PROPOSED RESIDENCE AT:

325 VIA LINDA

ARCOM # ARC-24-074

MAT-O.1

PROPOSED WEST ELEVATION - MAINHOUSE

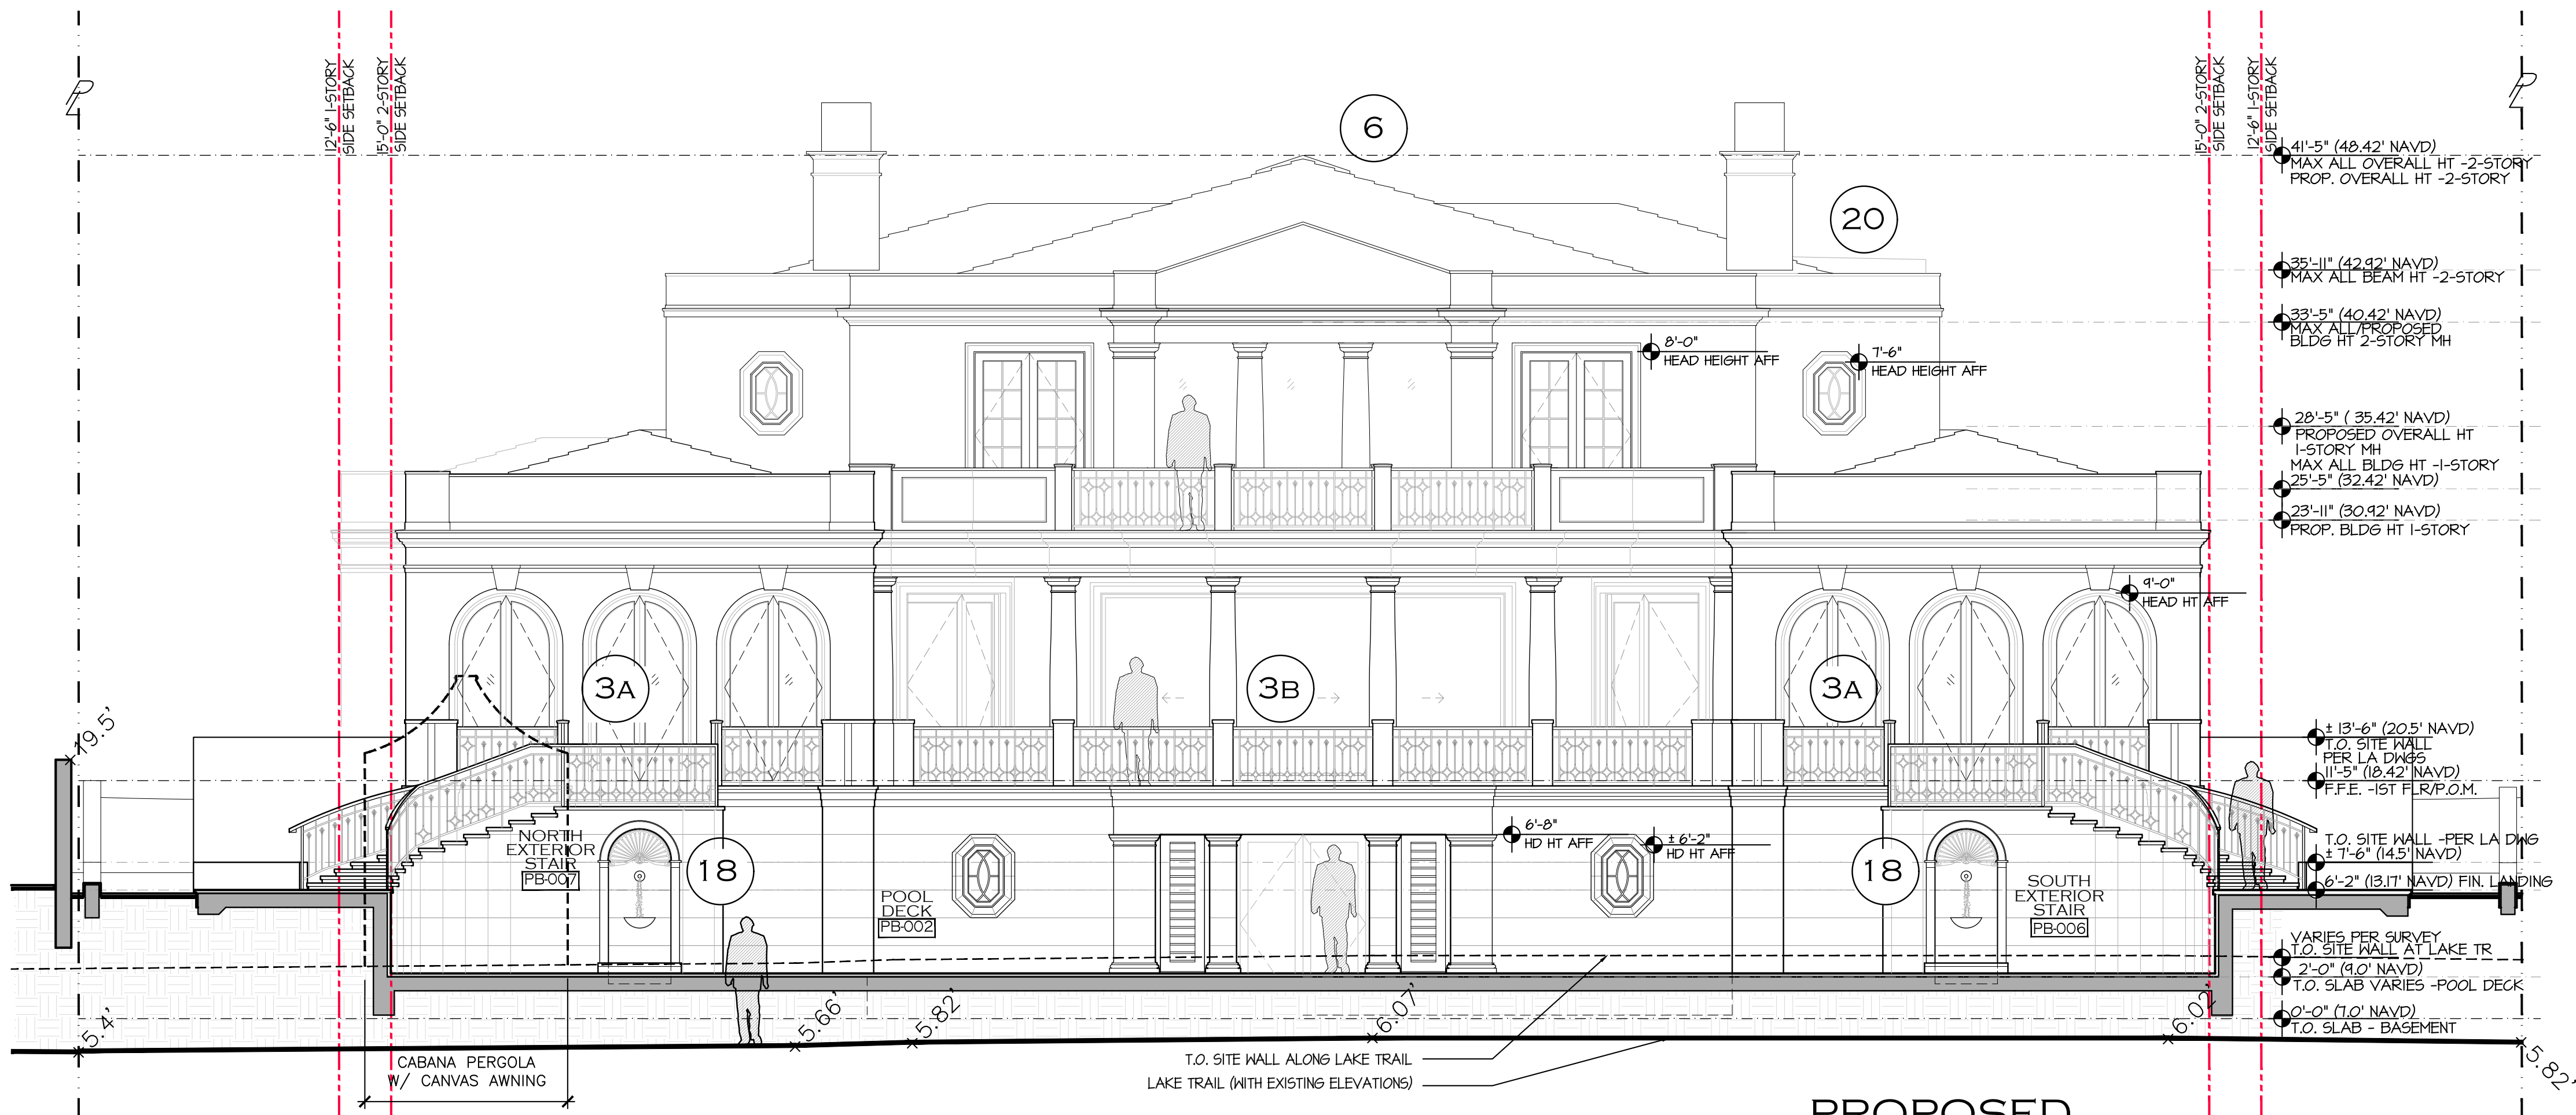
1. TYPICAL DOORS AND WINDOWS REVISED TO IMPACT RATED WOOD FENESTRATIONS, PAINTED WHITE IN LIEU OF BRONZE.
- 3a. PROPOSED (3) PAIRS OF DOORS AT EACH THE NORTH & SOUTH 1-STORY WINGS, IN LIEU OF FIXED UNITS.
- 3b. THE SLIDING DOORS HAVE BEEN REVISED WITH (3) PANELS IN LIEU OF (4) FOR AN UNINTERRUPTED VIEW AT THE CENTERLINE.

18. AT THE NORTH & SOUTH EXTERIOR STAIRS PROPOSED A WATER FEATURE AT EACH LOCATION TO BE ENGAGED/RECESSED IN THE STAIR WALLS.

20. OWNER'S REQUEST FOR A COMMERCIAL ELEVATOR WHICH REQUIRES ADDITIONAL HEIGHT, SEE ROOF PLAN FOR EXTENTS.

PROPOSED
NORTH ELEVATION - MAINHOUSE

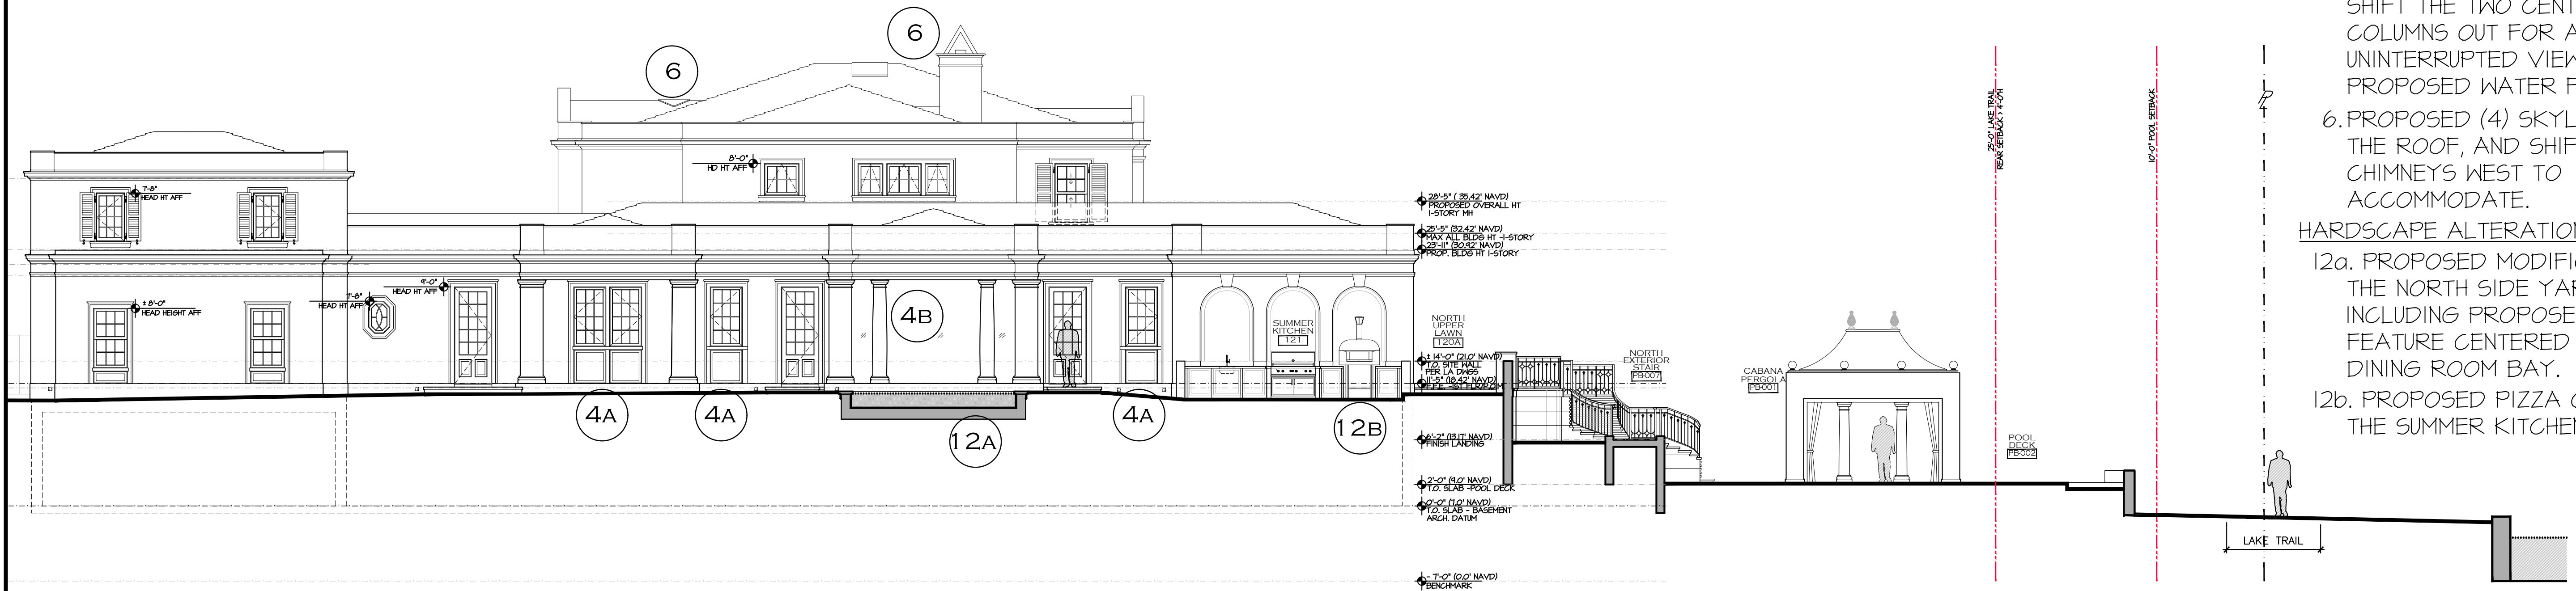
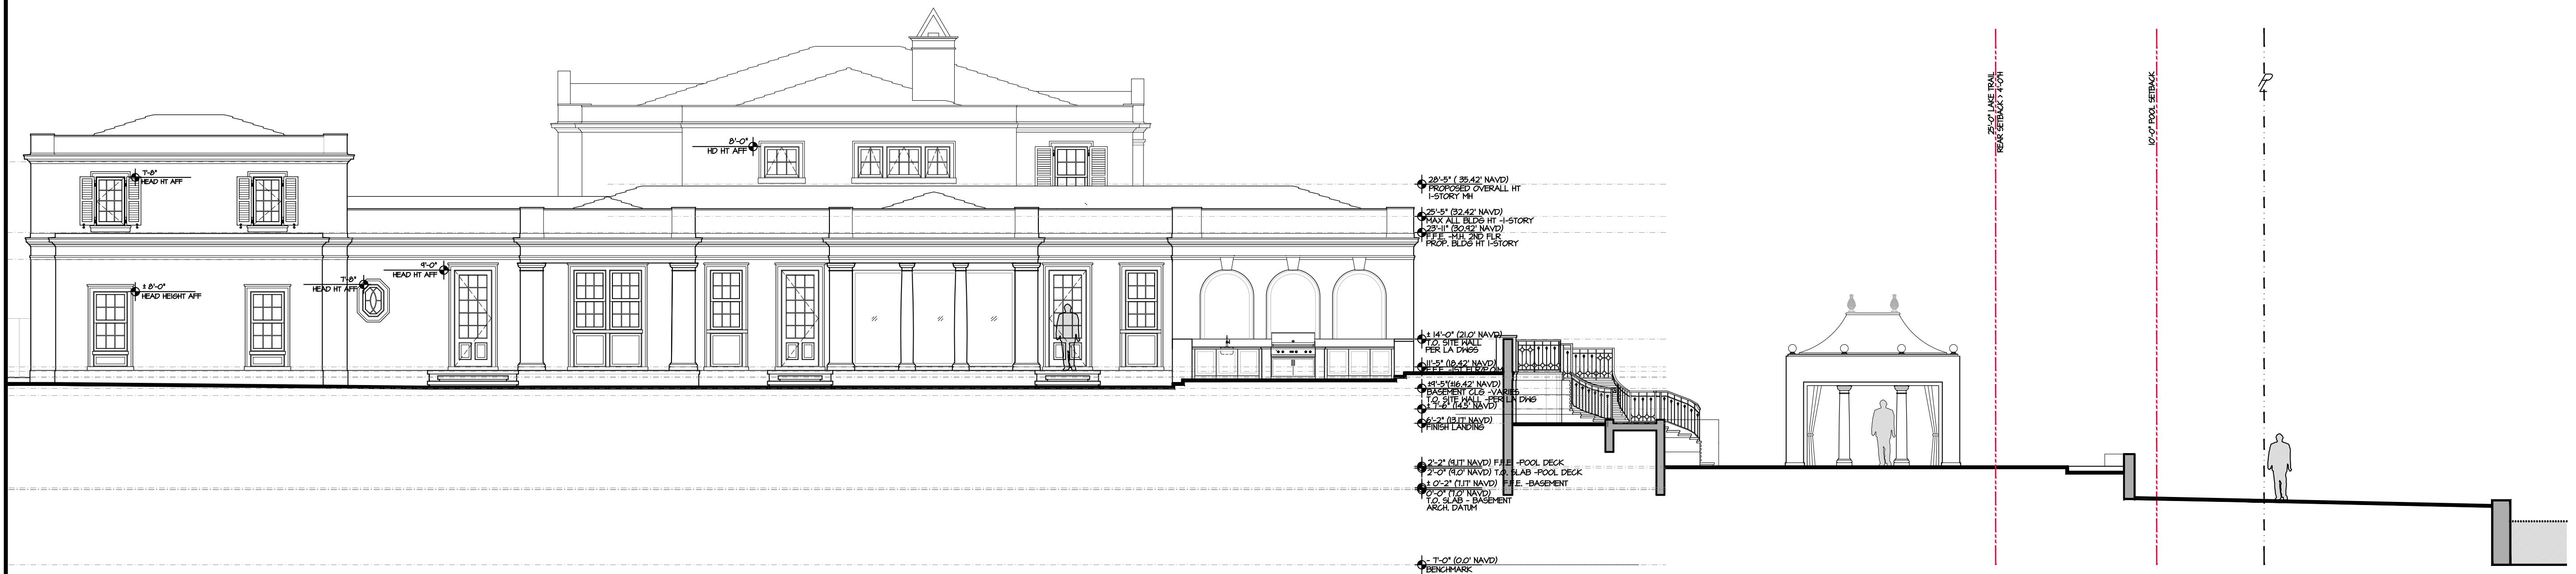
1. TYPICAL DOORS AND WINDOWS REVISED TO IMPACT RATED WOOD FENESTRATIONS, PAINTED WHITE IN LIEU OF BRONZE.
- 4a. PROPOSED (4) CASEMENT WINDOWS IN LIEU OF DOUBLE-HUNG.
- 4b. AT THE DINING ROOM BAY SHIFT THE TWO CENTER COLUMNS OUT FOR AN UNINTERRUPTED VIEW OF THE PROPOSED WATER FEATURE.
6. PROPOSED (4) SKYLIGHTS AT THE ROOF, AND SHIFT THE CHIMNEYS WEST TO ACCOMMODATE.

- 12a. PROPOSED MODIFICATIONS TO THE NORTH SIDE YARD INCLUDING PROPOSED WATER FEATURE CENTERED ON THE DINING ROOM BAY.
- 12b. PROPOSED PIZZA OVEN AT THE SUMMER KITCHEN.

PROPOSED
NORTH ELEVATION - GUESTHOUSE

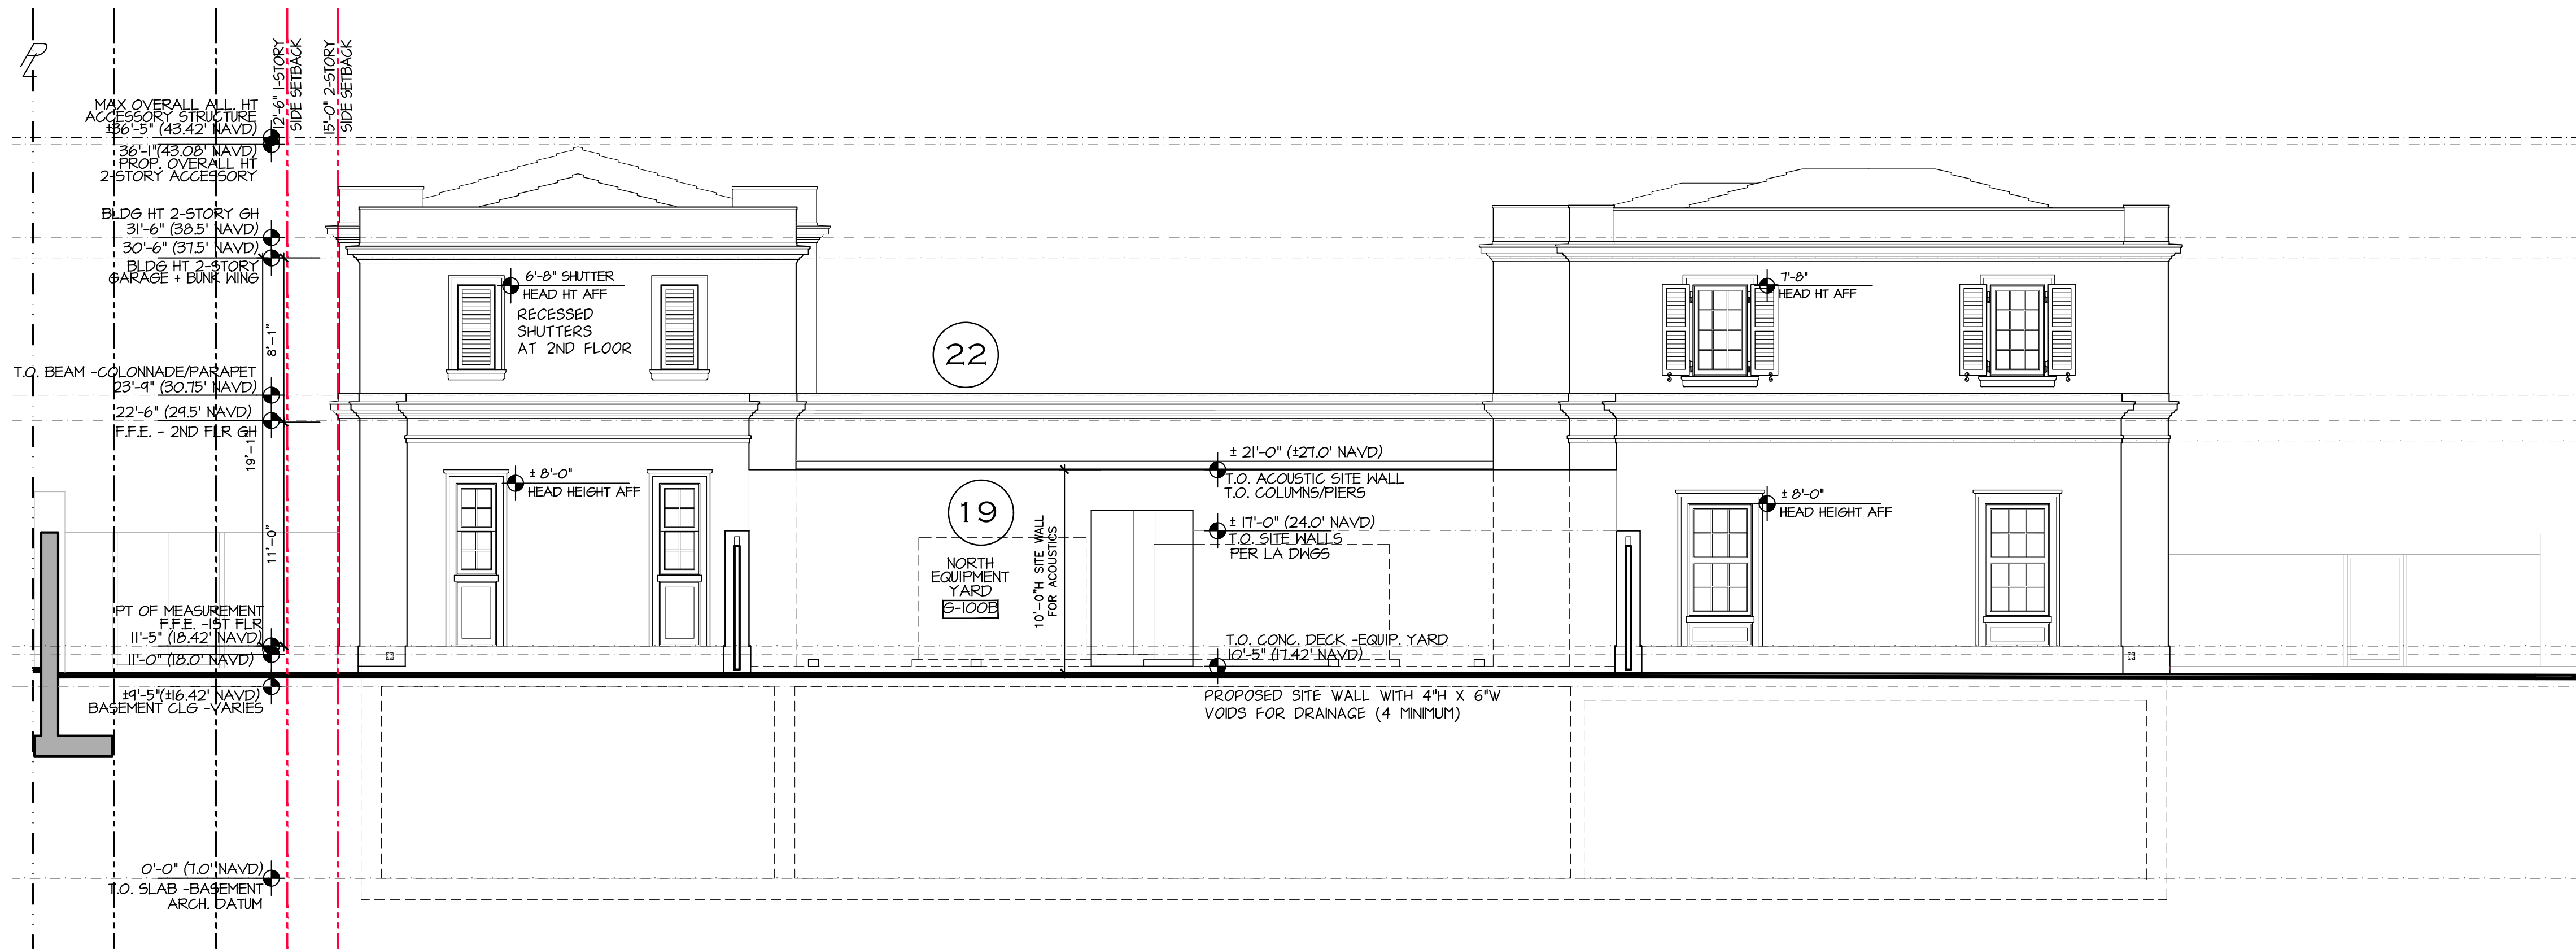
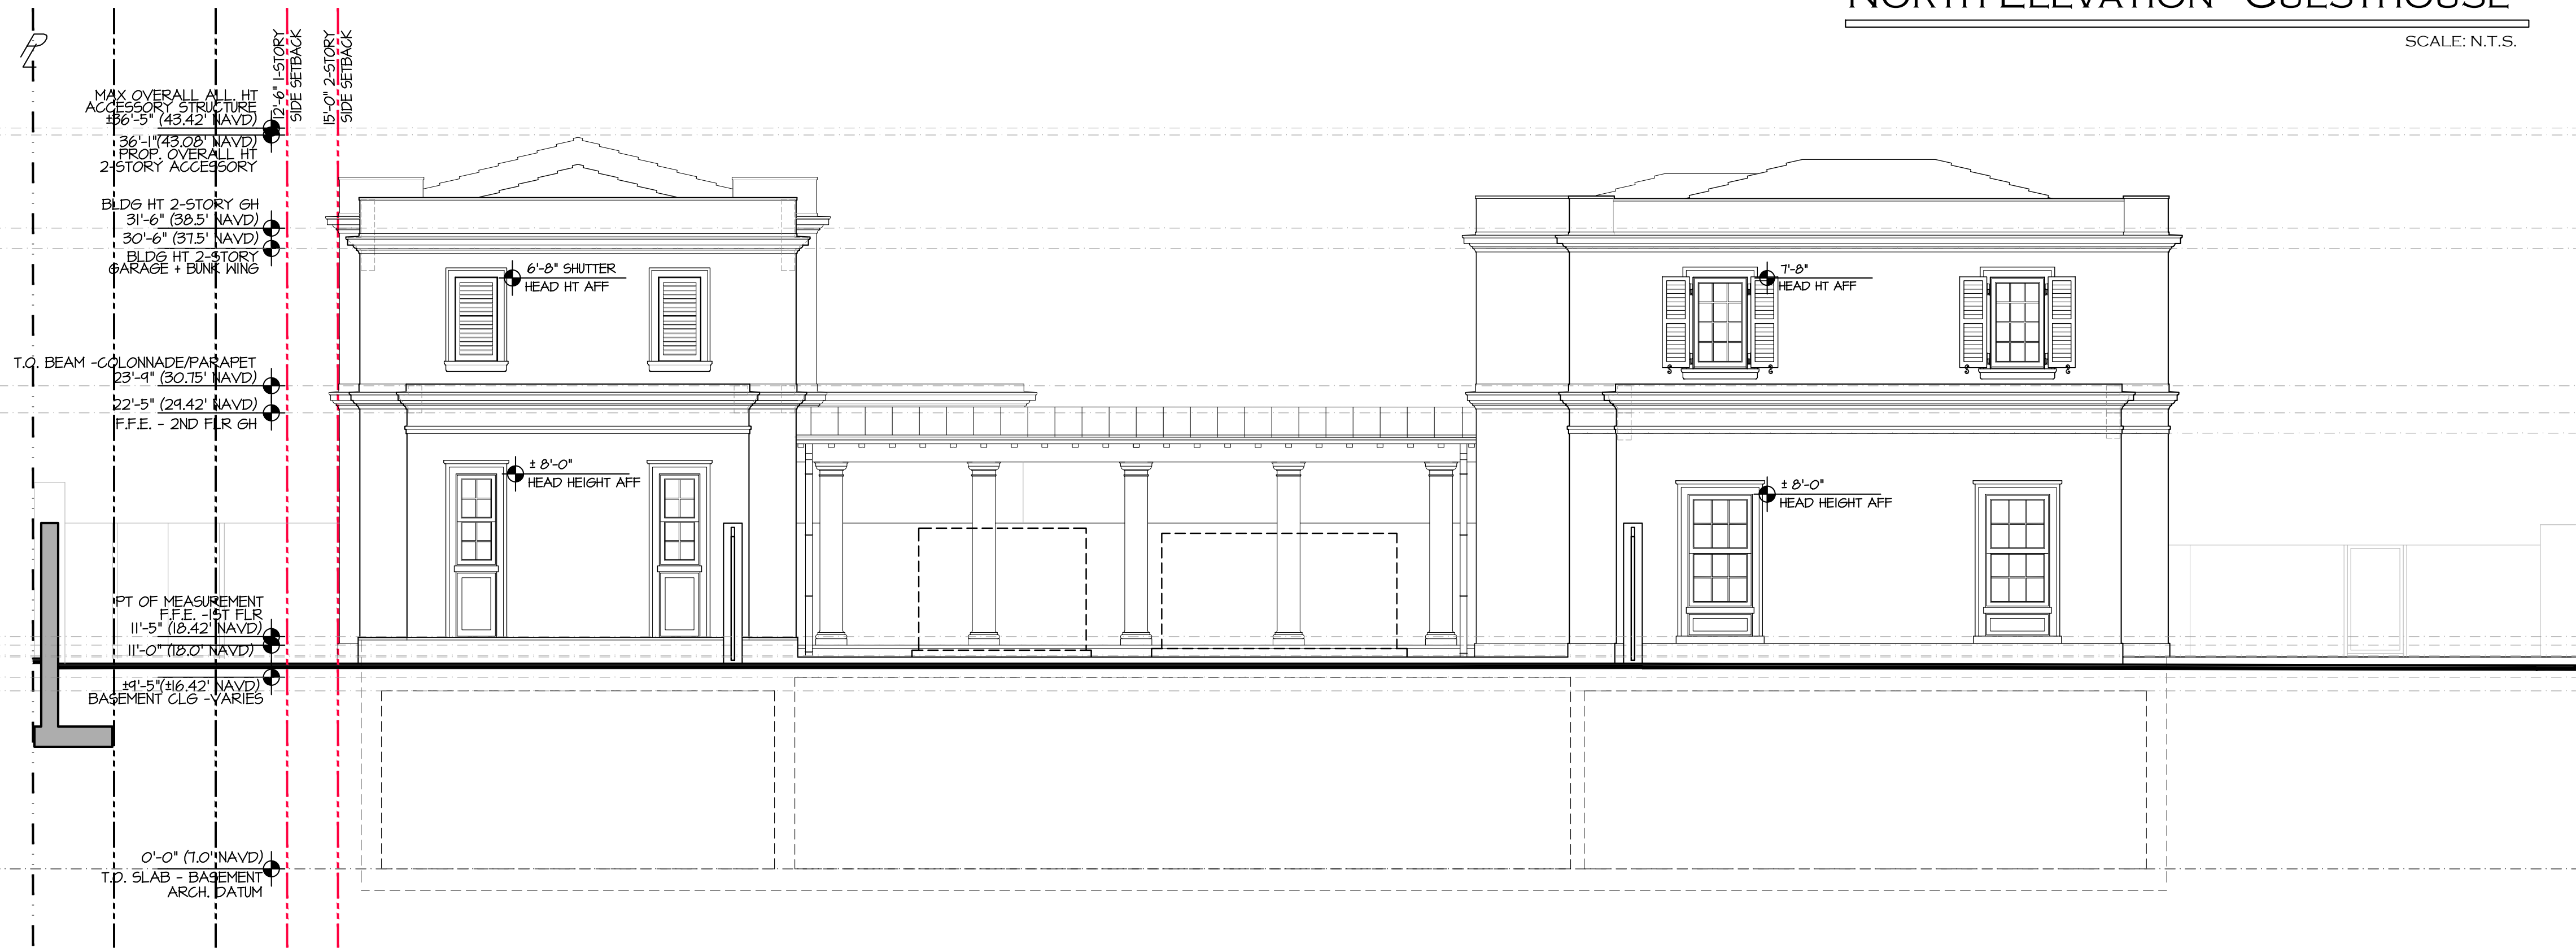
1. TYPICAL DOORS AND WINDOWS REVISED TO IMPACT RATED WOOD FENESTRATIONS, PAINTED WHITE IN LIEU OF BRONZE.

19. PROPOSED SITE WALL WITHIN THE BUILDING SETBACK AT THE NORTH EQUIPMENT YARD, PROVIDING AN ADDITIONAL LAYER FOR ACOUSTICS.

22. COVERED BREEZEWAY BEYOND AT GUEST HOUSE WITH PROPOSAL FOR SOLID NORTH WALL WITH PARAPET (SEPARATION FROM THE N. EQUIPMENT YARD), WITH ROOF SLOPING TO THE SOUTH IN LIEU OF PREVIOUS HIP. (PER FLOOR PLANS AND SECTIONS.)
